*Proceedings of the Madras Government, Public Works Department,
5th October 1875.*

No. 65. Read the following letter from JAMES MAY, Esq., Superintendent of the Madras Harbour Works, to Major-General G. W. WALKER, R.E., Secretary to Government, Public Works Department, dated Madras, 28th September 1875, No. 19 G. :—

No. 66. ORDER THEREON, 5th October 1875, No. 2,855.

laying of the
Site for the Foundation
Stone of the Madras
Harbour by H. R. H.
the Prince of Wales.

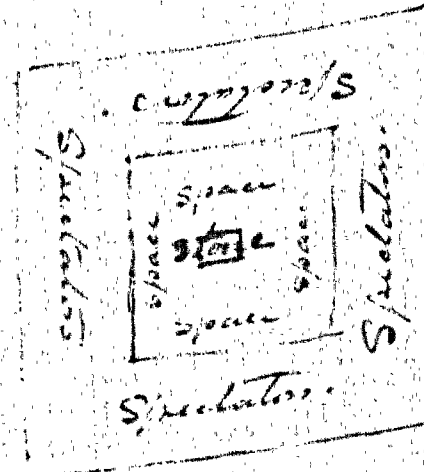
Q.2. How many people do you think
the enclosed ground could accommodate?

Q.3. Will seats or stands in
tiers be required to accommodate
spectators within the enclosed
part of ground?

Q.4. What size should the
opening be in the wall
stone for the coins, papers
&c. - to be deposited?

Q.5. Should there be an awning
or shade erected for H.H.H. & Co.
P.O. W.?

Q.6. Is an awning or shade
erected at the tent of
some kind or a more
permanent affair?

Q.7. Is the ceremony to come off
in the morning or in the
evening?

Q.8. About what width of clear
space should there be left
between the stone and the
spectators within the enclosure?

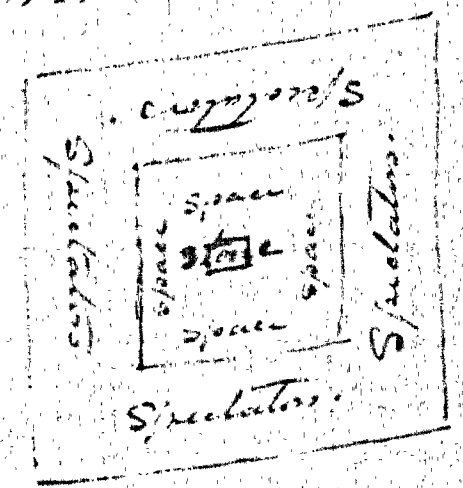
Q.2. How many people do you think the enclosed ground should accommodate?

Q.3. Will seats or stands in tiers be required to accommodate Spectators within the enclosed piece of ground?

Q.4. What size should the opening be in the under stone for the Coins, Papers &c. - & be deposited?

Q.5. Should there be an Avenue or Shade erected for H.R.H. the P.R.N.?

Q.6. Is an Avenue to be erected behind at the tent of some kind or a more permanent affair?

Q.7. Is the Ceremony to come off in the morning or in the evening?

Q.8. Point out what width of clear space should there be left between the stone and the Spectators within the enclosure?
